REMARKS:

Attorney Docket No. SII-1000 [SIMG-0115]

Application Serial No. 10/036,234

FIG. 2

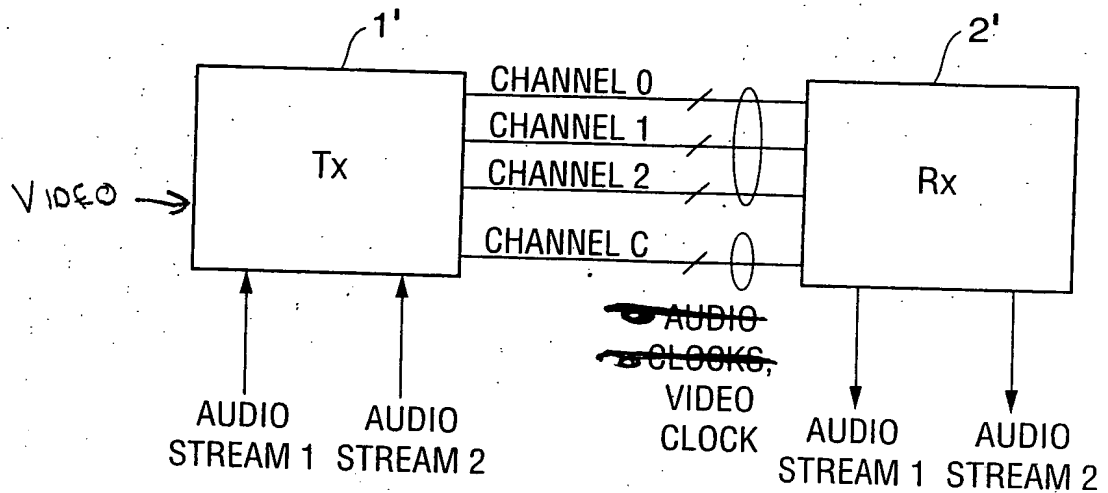
Also, attached for review and approval by the Examiner are proposed revised versions of Figs. 2, 3, and 5 with the proposed changes shown in red ink. The proposed revised drawings are being submitted simultaneously to the Official Draftsman for review. The proposed change to Fig. 2 is to conform Fig. 2 to the description thereof at page 16, last paragraph, of the specification. The proposed change to Fig. 3 is to conform Fig. 3 to the description at page 22, last line to page 23, line 3, and page 23, last paragraph, of the specification. The proposed change to Fig. 5 is to conform to the description at page 22, lines 11-25, of the specification.
